From: [REDACTED]
To: [REDACTED]
CC: [REDACTED]
Sent: 3/3/2021 8:44:58 AM
Subject: RE: O8W-PM [REDACTED] Bucks Creek 1101 Phase 1,2&3 - Pre-Engineering Meeting

Bucks Creek 1101- PM# [REDACTED] Overview Map

Subject: O8W-PM [redacted] - Bucks Creek 1101 Phase 1,2&3 - Pre-Engineering Meeting

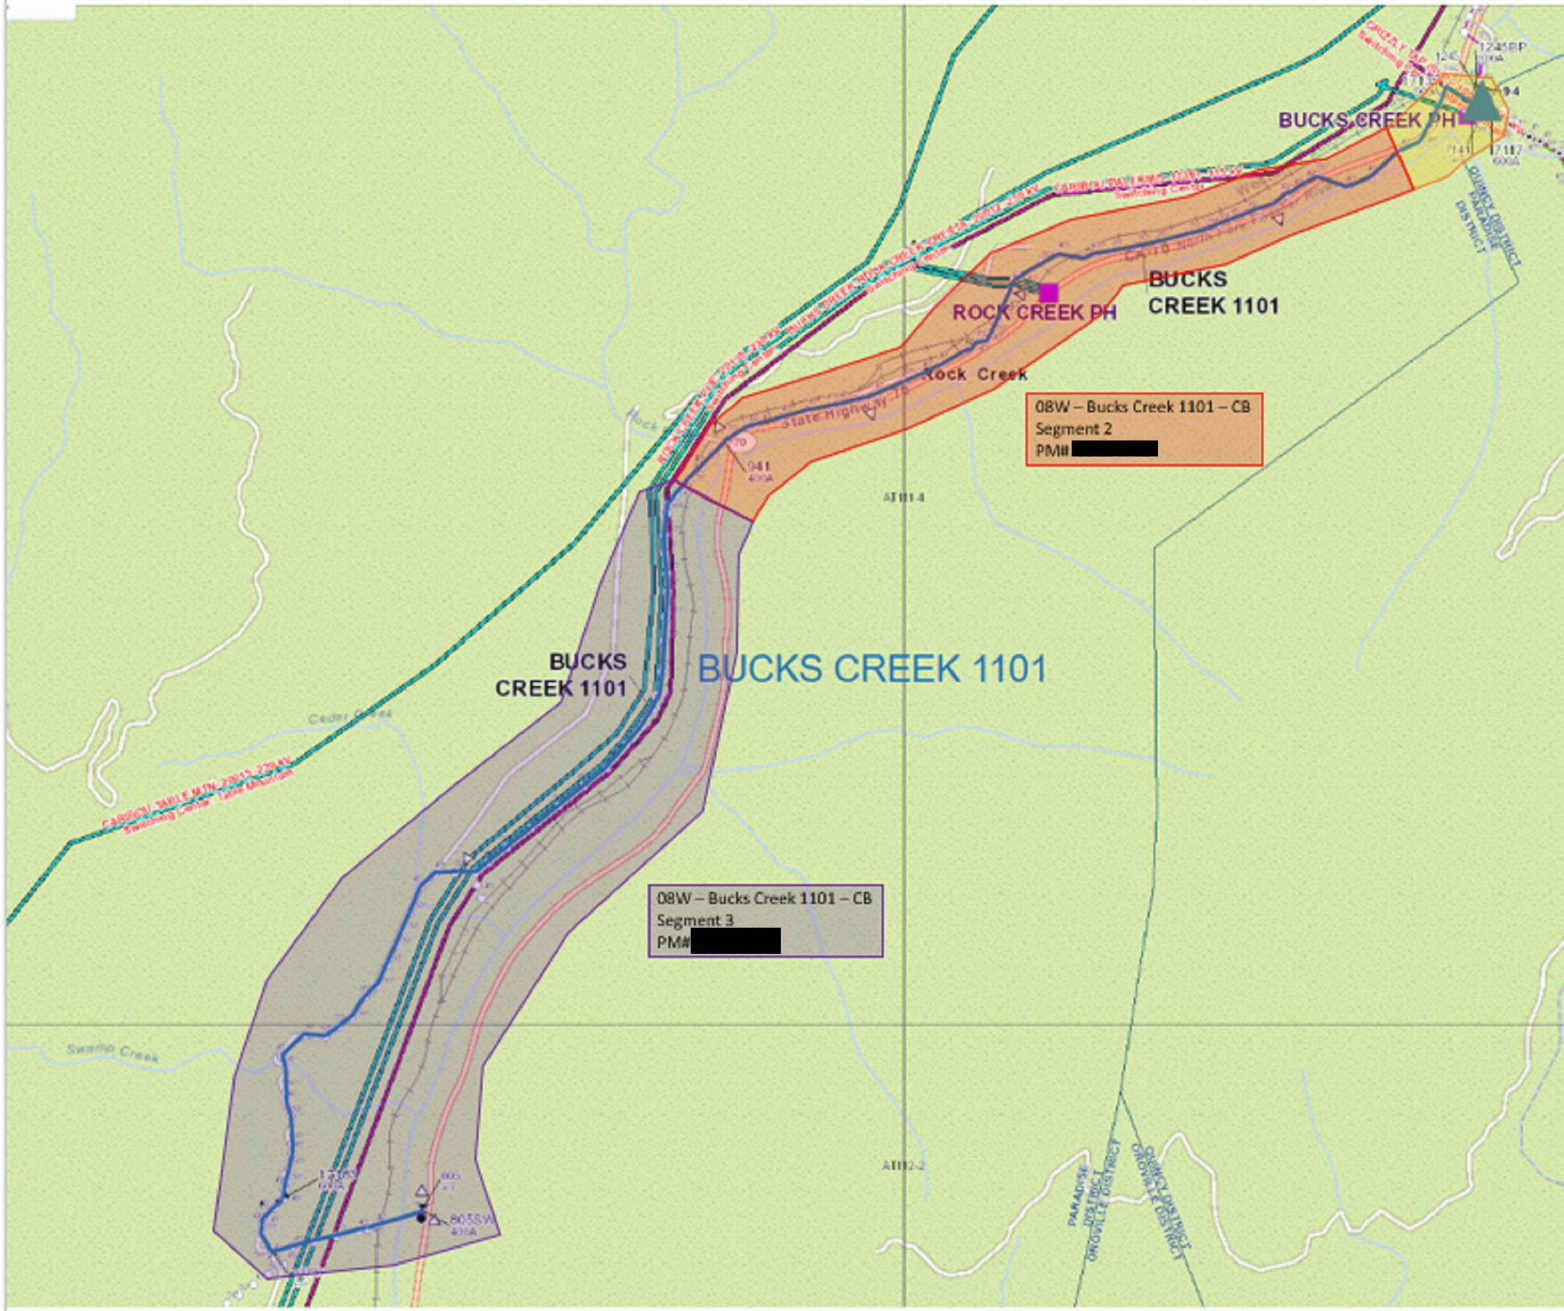
Attached are the 'base-map' limits in a kmz. file. As you will see, we need our base-map to go about ~100' into the tunnel at the south end (see pedestal in picture below....please begin about ~50 beyond this point which is about ~100' beyond the Cresta Dam).

We want to end the base-map at the sign location below which is roughly at MM (Mile Marker) 5.10.
